Service Bulletin

SAFETY RECALL

2004 CBR1000RR Inaccurate Speedometer

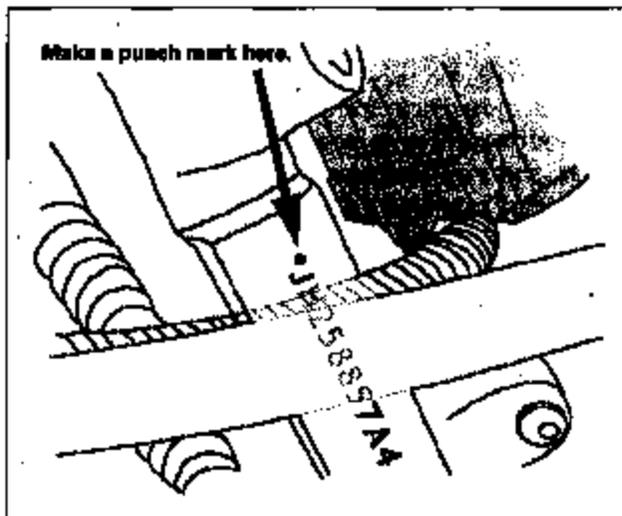
- If the unit has been repaired, you will find a punch mark in front of the first letter of the VIN. This indicates the unit has already been repaired and no further action is required.
- If the unit has not been repaired, proceed to the REPLACEMENT PROCEDURE section of this Service Bulletin.

After you have completed the Replacement Procedure, make a punch mark in front of the first letter of the VIN as shown below.
